# TECHNICAL INFORMATION

74649

**Subject** ▶ Change of Gear Housing

**For Models** ▶ DA3010, DA3010F

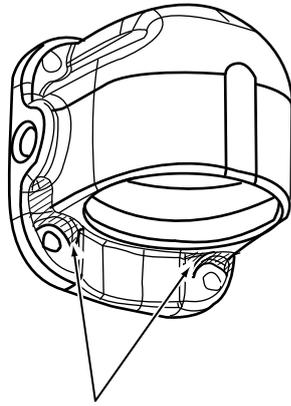
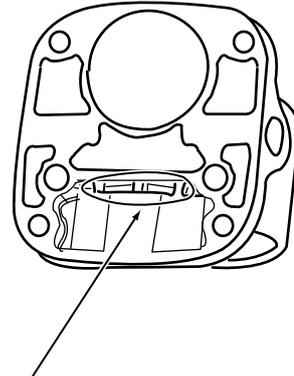
**Description** ▶ Gear housing has been changed as illustrated below for further improvement in durability,

Increase of wall thickness

Addition of ribs

Item No.	Current part		Q'ty	I/C	New part		Q'ty	Note
002	Gear Housing 317635-3		1	Yes	Gear Housing 317635-3		1	The part No. remains the same.
